NIAGARA MOHAWK POWER CORPORATION

LICENSE NO. DPR-63

DOCKET NO. 50-220

Proposed Changes to Technical Specifications (Appendix A)

FIGURE 2.1.1 FLOW BIASED SCRAM AND APRM ROD BLOCK

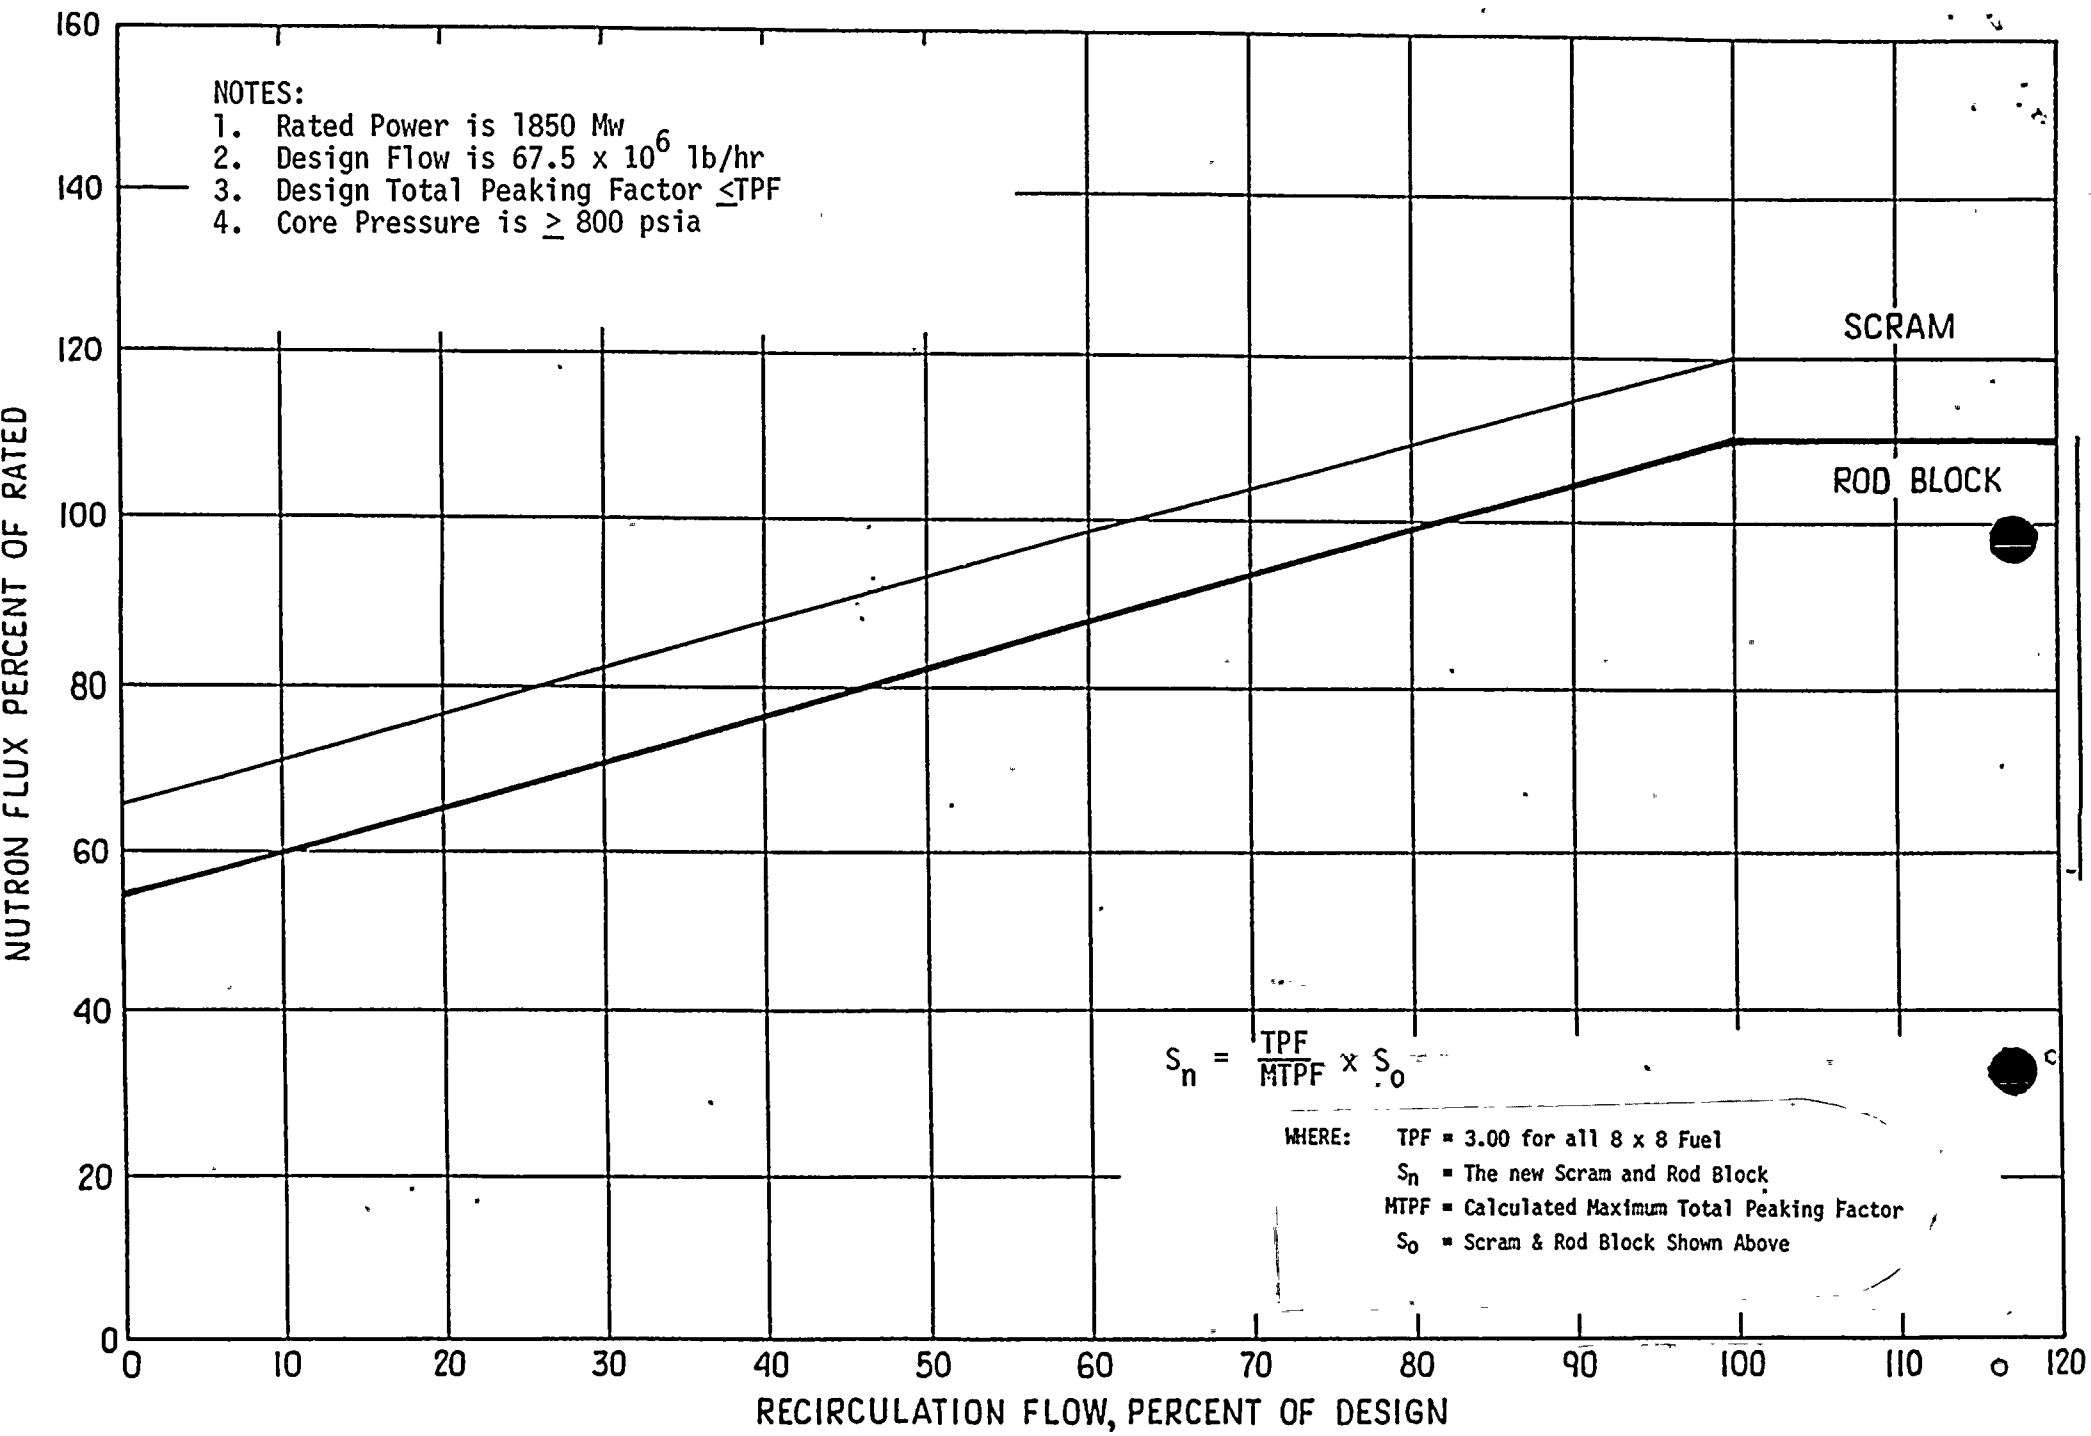
The proposed amendment to Sections Figures 2.1.1 and 3.1.7.aa of the Technical Specifications reflect changes required to prevent unnecessary restriction of operating ranges and provide consistency with the current reload analyses for the present Nine Mile Point Unit 1 core configuration and parameters (Reference 1 and 2). Reference 2 has been enclosed for your convenience.

At present, the rod block line is given by the line $RBL = .55w + 50$. This line coincides with the P/F line. With the expanded P/F map, this line will be moved to $RBL = .55w + 55$. This line is above the P/F line. Therefore, conservative setting of the RBL (done to ensure that the drift of the RBL will not result in a technical specification violation) will not restrict the low flow operation. The only analysis affected by the RBL change is the rod withdrawal error. The change in the RBL increases the delta CPR for this

Figure 3.1.7.a a LIMITING POWER FLOW LINE

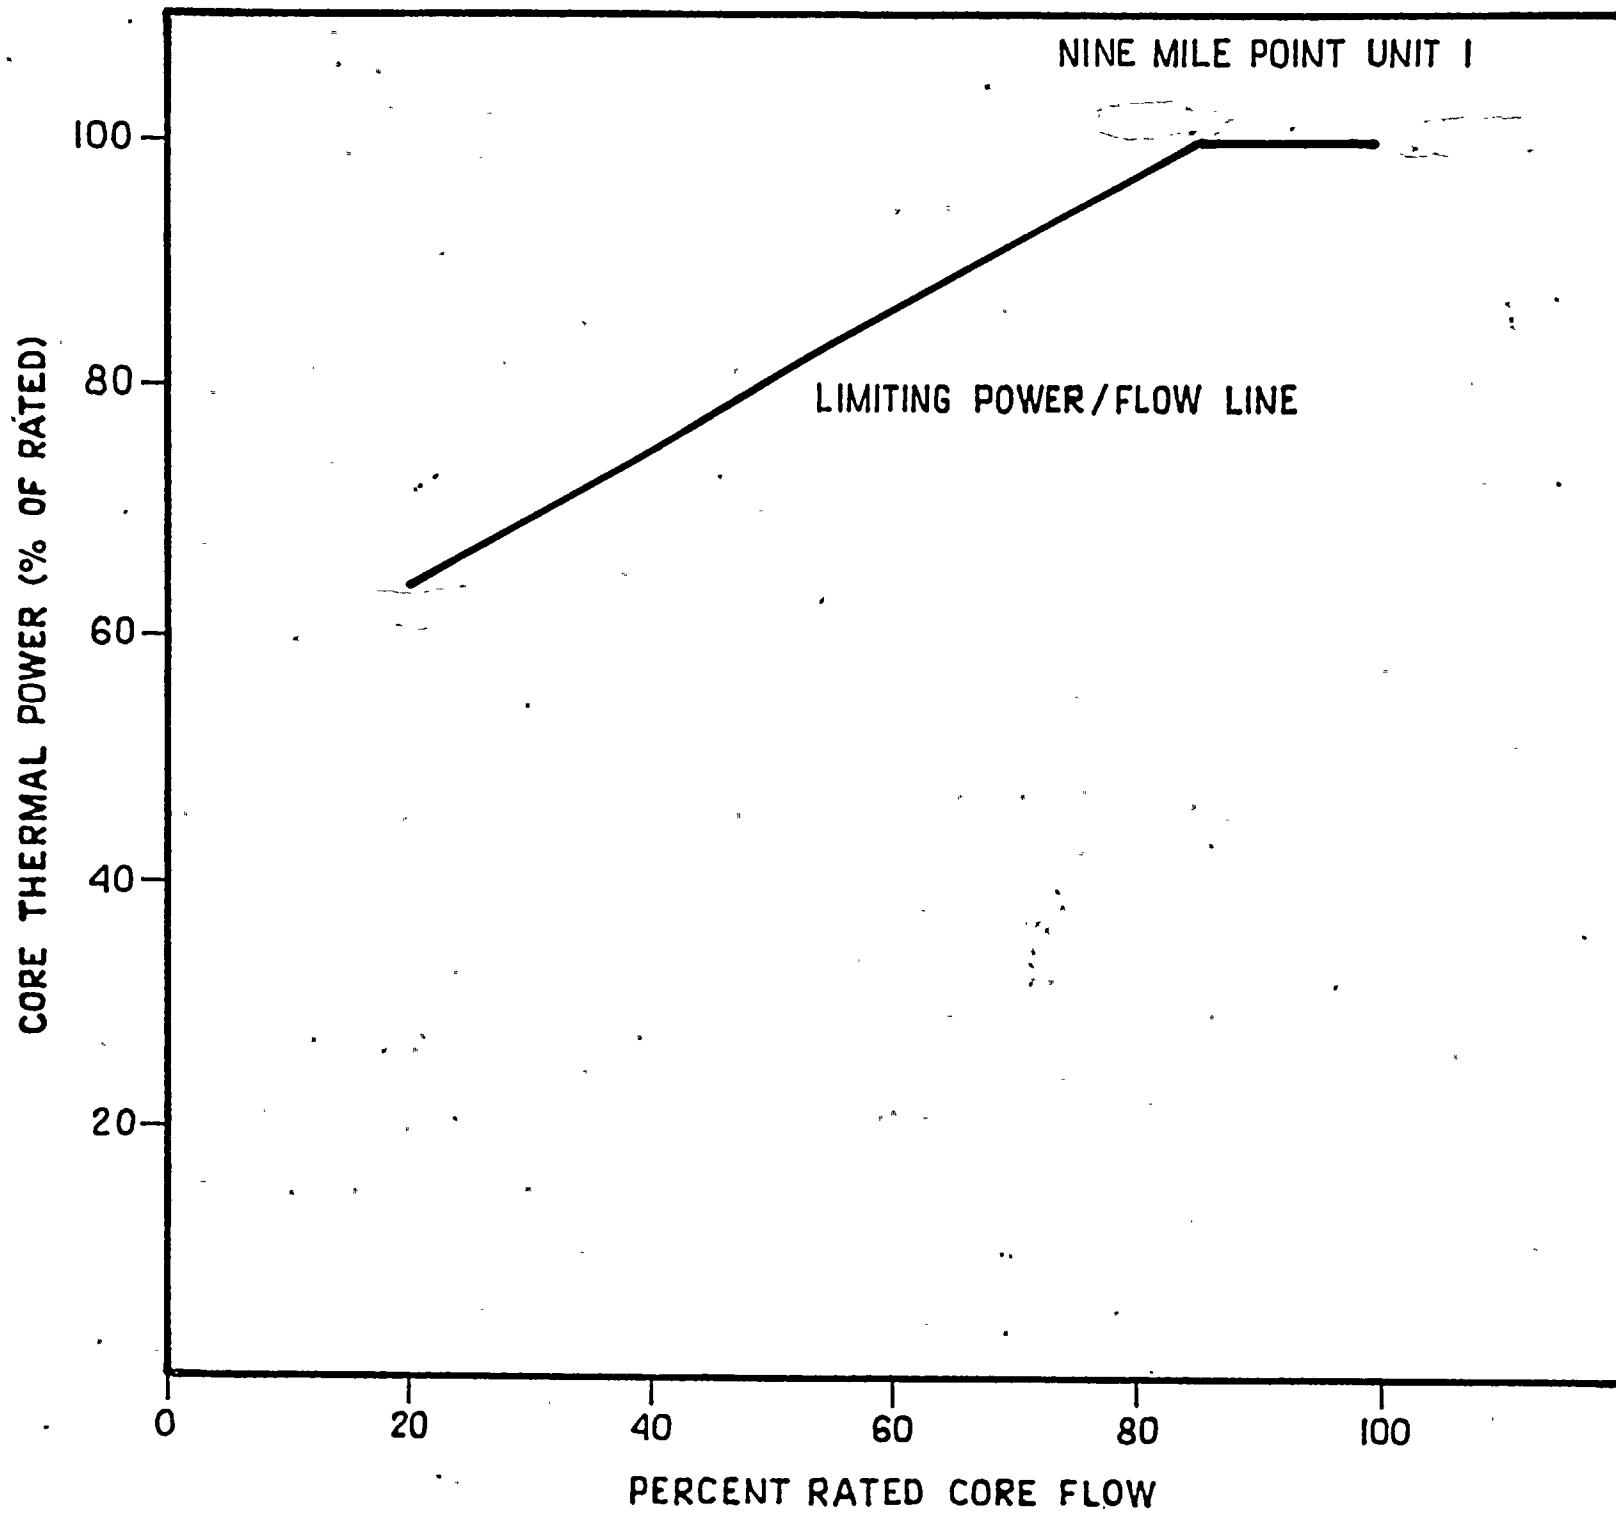
At present, the technical specifications limit full power operation to the flow range from 91 percent to 100 percent of rated core flow (67.5 MLBs/hr). Below 91 percent flow thermal power is limited to the line defined by $P = .55w + 50$ (P = percent thermal power and w = percent core flow). In practice, this region is further restricted by the APRM rod block line. The Rod Block Line (RBL) is limited by the technical specifications to $RBL = .55w + 50$. This is the same as the power flow limit. In order to ensure compliance with this limit, Instrument and Control sets the RBL slightly below the technical specification limit. This effectively limits full power operation to a flow range of about 94 to 100 percent core flow. The proposed modification will change the range of full power operation to be between 85 percent and 100 percent. Below 85 percent flow the power level will be limited by $P = .55w + 53$. The RBL will be defined by $RBL = .55w + 55$. Thus, even with the conservative setting of this line, it will not constrict the operating map. The present Power/Flow (P/F) line and the new P/F line are shown in Figure 1.
